Informal document **GRRF-83-26**
83rd GRRF, 23-27 January 2017
Agenda item 6

UN Regulation No. 90

Special Interest Group, SIG

2nd Meeting, IDIADA Spain 19th October 2016

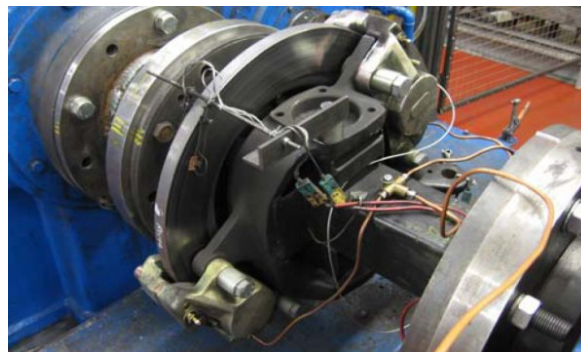
- Consideration of other materials (Carbon fiber...)
- **Carbon ceramic** discs can be approved as AM provided that the original R13H includes carbon ceramic OE
- Carbon C, cannot be the replacement for an classical friction OE material approve to UN R13H
- Same for brake pads specific for these
